Record ID: PLN-MAR-20-00007 Filing Received: 04/06/2020 Pre-Application Date: 02/21/2020 Filing Fee: \$550.00

# MAP AMENDMENT REQUEST (MAR) APPLICATION

PRELIMINARY DEVELOPMENT PLAN

# STAFF REPORT ON PETITION FOR ZONE MAP AMENDMENT PLN-MAR-20-00007: ANDERSON COMMUNITIES, INC.

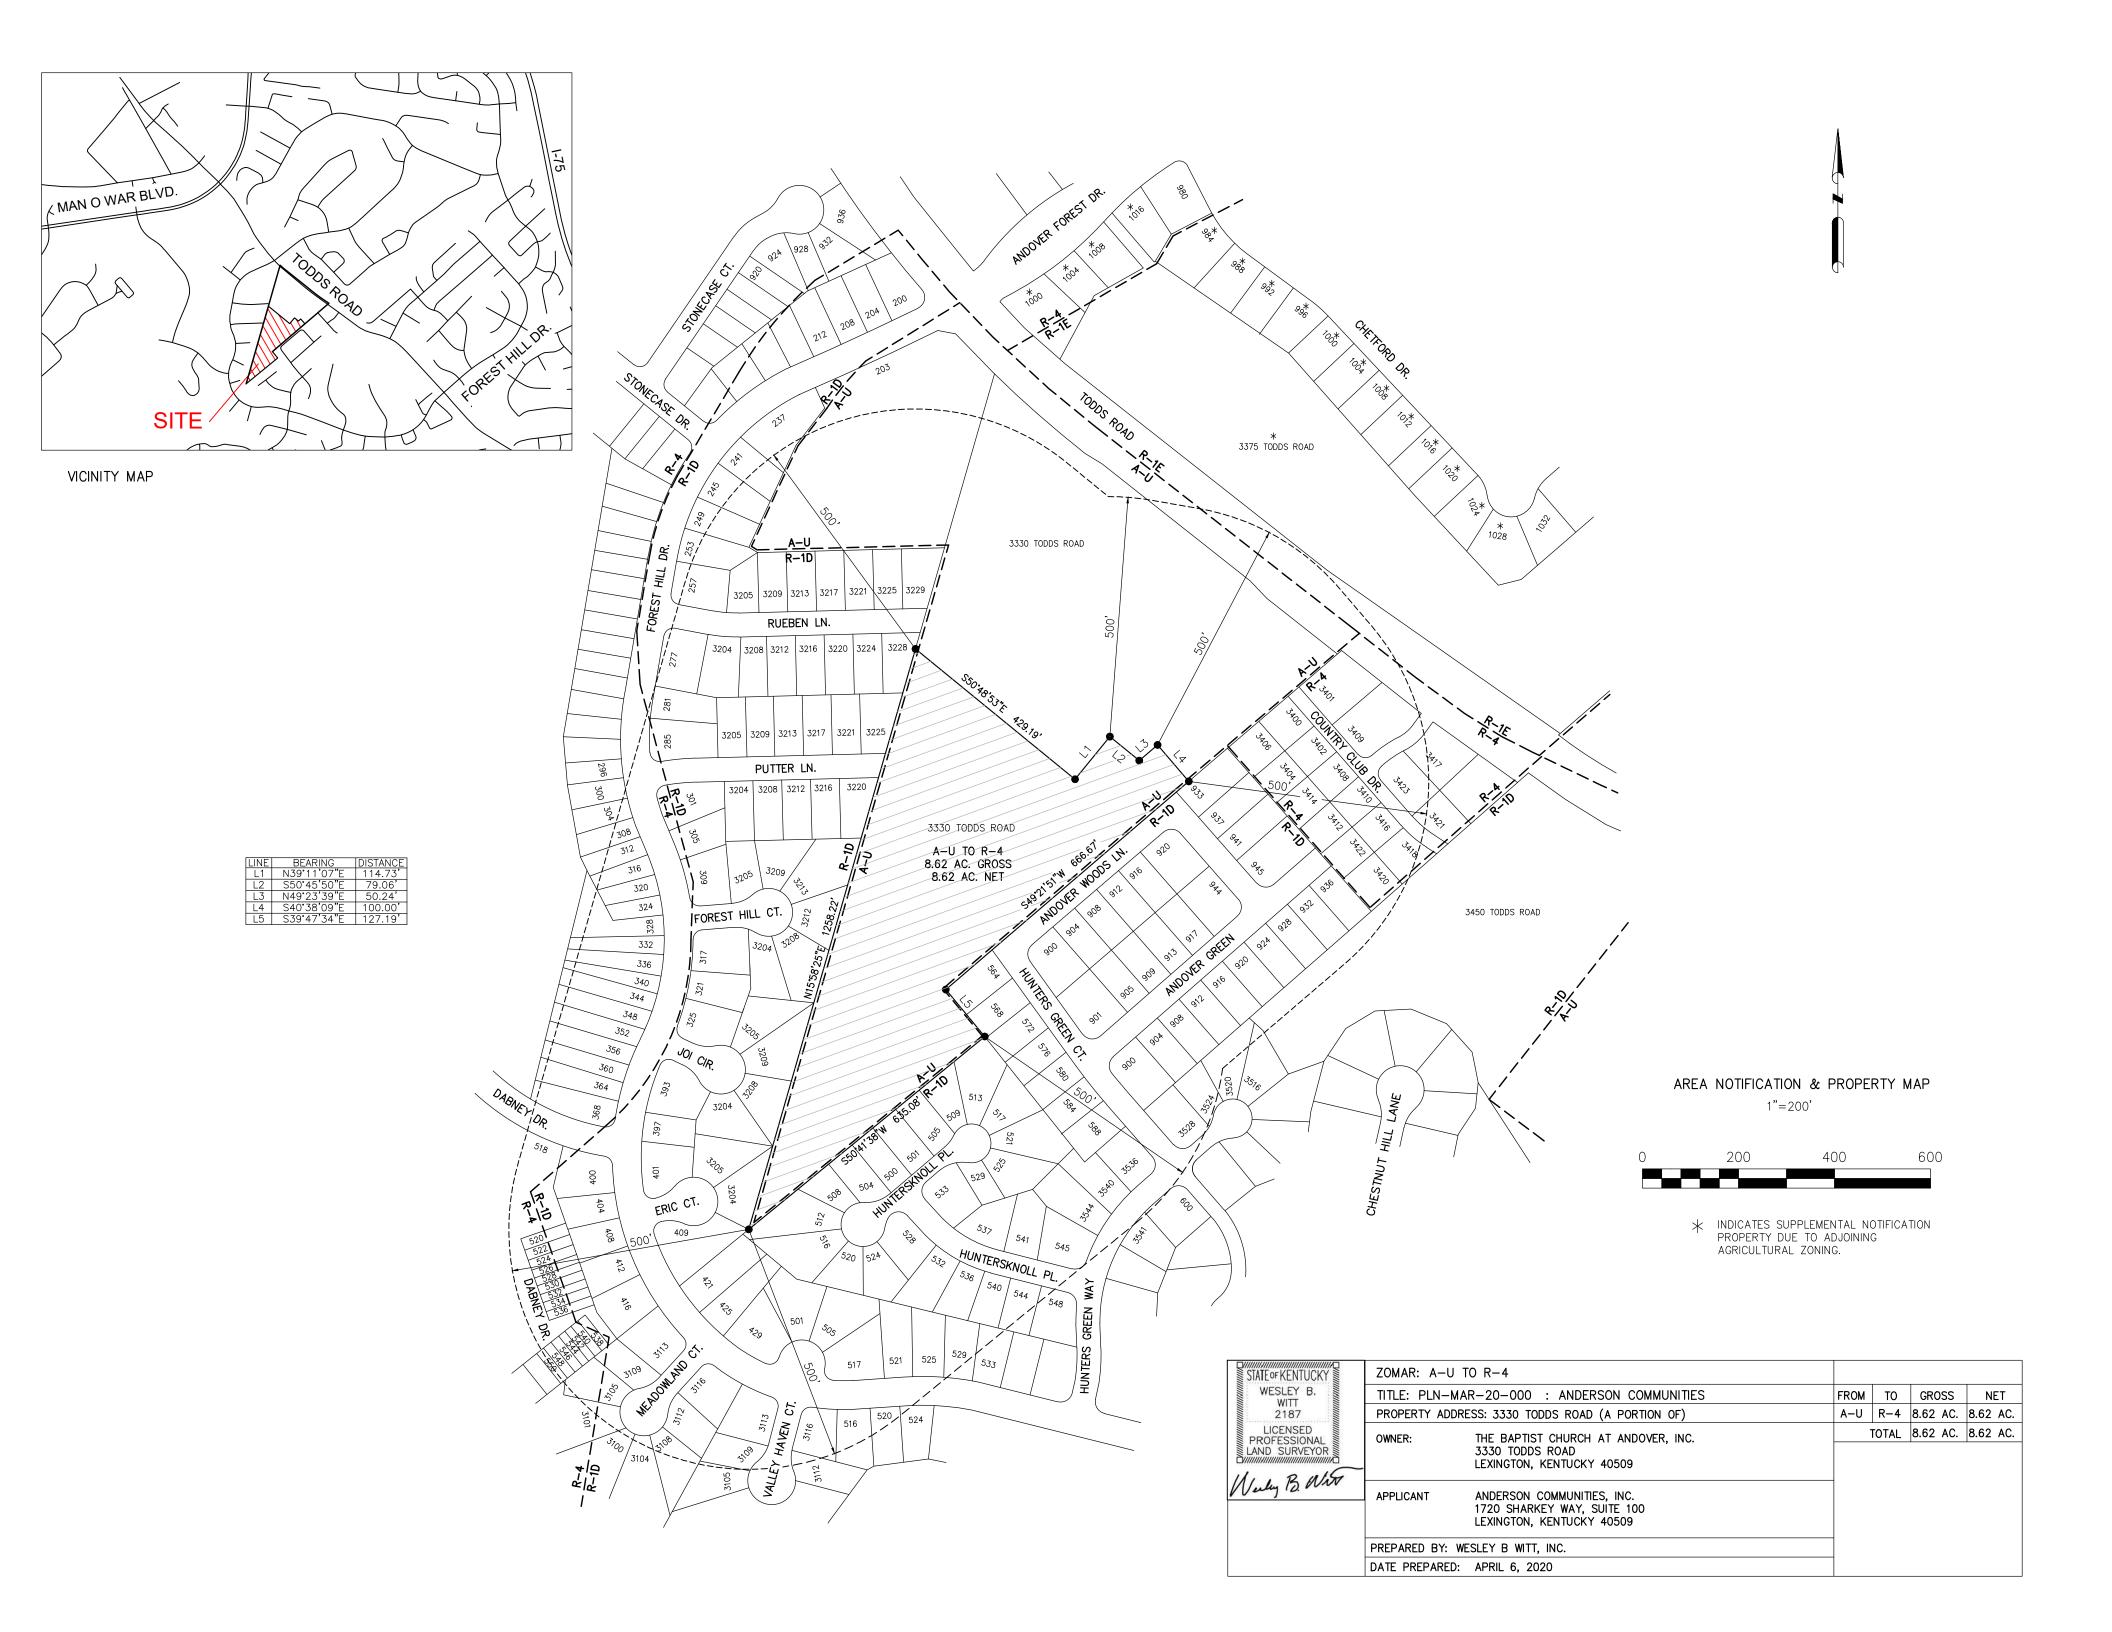
The applicant touches upon a select few aspects of the multi-family design standards, including wall planes, height step downs, breaking up structures, and screening surrounding the multi-family development. Staff would like the applicant to comment on how the pedestrian walkways are connecting with the structures themselves and where the main points of access are located. Furthermore, the applicant should describe how they are integrating the development into the surrounding neighborhood.

As this development is increasing the overall utilization of the property, the applicant should utilize green infrastructure on-site or expand upon how it is not possible. While staff does not require engineering of this infrastructure at this time, a commitment to its inclusion would meet the policies of the Comprehensive Plan, while also acting to prevent adverse impacts caused by the proposed development on the environment and on any adjacent properties.

The applicant is showing access to a walking trail at the rear of the property that will circle the associated detention basin. This amenity provides both a community facility and activates the greenspace at the rear of the property; both elements are promoted throughout the Comprehensive Plan. However, the proposed development is depicting garages separating the primary portions of the development from this amenity. This creates a discontinuity between the site, as well as a potential safety issue. By screening the trail, the potential for "eyes on the street" interaction is dramatically lessened, which can lead to an unease or dangerous situations for those utilizing the trail. This is especially true for a development that is focused on providing a safe space for seniors, who are statistically more likely to have issues or injuries related to slips, trips or falls.

Additionally, while the petitioner is seeking to integrate the multi-family housing with Putter Lane, allowing for the access to the walking trails and connections to Todds Road and the Baptist Church of Andover, they are closing off access to those properties located on Andover Woods Lane and the ten (10) single family residences that are being proposed with this development. While the multi-family housing is the primary driver of this proposed zone change, the potential residents of the detached single family households should be provided with access to both the walking trails and the surrounding amenities. Should pedestrian access be closed off to these properties, any resident would need to walk approximately 1 mile to reach the same facilities and place of religious worship.

The applicant should seek to provide direct connections between the proposed development and the surrounding neighborhoods, integrating the development, rather than creating barriers between the different portions of the community.

In addition to the staff's concern regarding the secondary access point, staff is also concerned with the integration of the proposed apartment complex to the neighborhood. Currently, the applicant shows a pedestrian connection that extends from both the ten (10) single-family houses and the apartment complex out to Todds Road, but no connection between the two developments. The applicant is therefore turning the backs of the single family housing to the apartment buildings, creating a barrier between the two rather than buffering, transition or integrating. The Comprehensive Plan stresses the need for greater continuity and integration of different forms of housing, not just through context or architecture, but through integrated roadway and pedestrian systems that allow for proper vehicular and pedestrian circulation (Theme A, Goal #3). The Multi-Family Design Standards stress this integration and go further to state that there is a need to connect to adjacent subdivisions and neighborhoods through an integrated street network (SP.10). This street network does not need to include vehicular access, but should definitely include direct pedestrian connections.

Staff considers the access point a threshold issues and must recommend disapproval of the proposed zone change for the property located at 3330 Todds Road (a portion of).

- A-DS3-1: This criteria relates to compliance with multi-family design standards in Appendix 1. Please see the attached memorandum from Tony Barrett, Barrett Partners, Inc., relating to the guidelines for site planning and open space and landscaping. In addition, as it relates to architectural design, our use of single-family homes along Andover Woods Lane transitions to the multi-story senior living facility. Also, the single-family homes as well as the garages act to transition to the multi-story buildings (AD.1 and AD.2). The building mass is broken up with articulation on all sides using varying roof shapes, setbacks, materials, colors, building heights and landscaping (AD.3). We maximize window numbers and size (AD.4) and avoid large areas of blank wall facings (AD.5). We utilize patios and balconies (AD.6) and façade detail (AD.7). All sides of the building maintain architectural design (AD.8). As mentioned above, built in transitions include the single-family homes, garages, and step down in heights of the proposed buildings, as well as landscaping setbacks, and adjustments in bulk and massing (AD.9).

- **B-SU11-1** This criteria relates to green infrastructure. We have added Note 12 to the plan stating that green infrastructure practices, such as permeable paving, porous asphalt, bio-swales, or rain water harvesting shall be incorporated into the stormwater plan for the property.

- SP.1 Buildings 1 & 2 are positioned on Putter Lane as such to present an attractive elevation to the street while creating an identifiable courtyard entry to the community.

- SP-2 For the security of the residents, front entrances to individual units will not be provided.
- SP-3 Building entries are located at prominent locations and will be architecturally prominent on the building façade. Such locations and architectural embellishment will visually define the entrances. The entrances will be accessible to the street by the network of walks through out the site.

- SP.4 The building setbacks are typical for the area and the proposed zone. The irregular shape of the apartment property makes alignment of the buildings on the setback lines difficult. Setback of the single-family homes on Andover Woods Lane will match the existing homes on the street.

- SP.5 The network of sidewalks links the community to Putter Lane, Todds Road and Andover Woods Lane. Sidewalks lead to the adjoining Baptist Church, and nearby is the Andover Club and Brighton Place Shoppes.

- SP.6 The apartment clubhouse is located internal to building 1 and is directly linked to the other buildings by sidewalks and internal hallways.
- Sp.7 Most of the parking is located to the rear and side of the property. The irregular shape of the parcel makes aligning the units to the public street difficult. The small parking area fronting on Putter Lane is screened with landscaping.
